Product Change Notification

Change Notification #: 110191 - 00
Change Title: Intel® Celeron® Processor P1053, and Intel® Xeon® Processors EC5549, LC5518, LC3528, LC3518, EC5539, EC5509, EC3539, LC5528, and LC3538, PCN 110191-00, Product Marking, Removal of “i” from beginning of Processor Name
Date of Publication: August 27, 2010

Product Marking

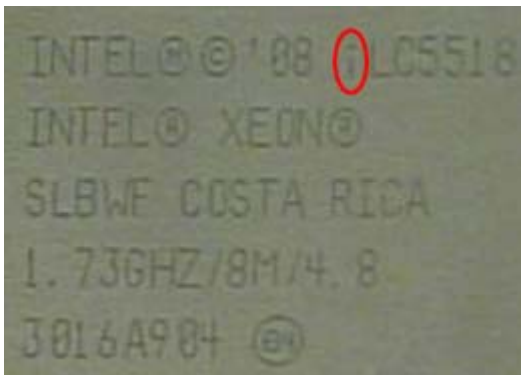
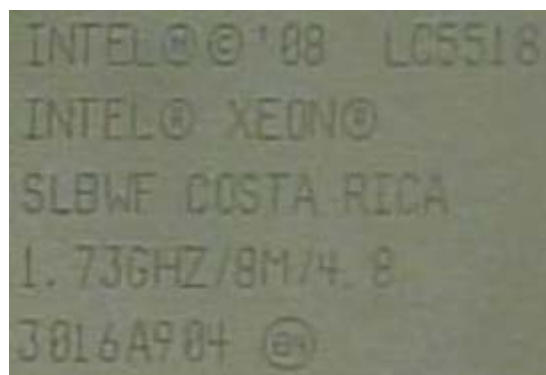
The topside mark will be modified to remove the “i” on the processors listed in the Products Affected table below. This “i” is not part of the processor number and will be removed going forward.

Intel anticipates no impact to customers. There are no functional differences between processors marked with an “i” and those marked without it. While we are switching to the new mark you may receive some processors with the “i” and some without it.
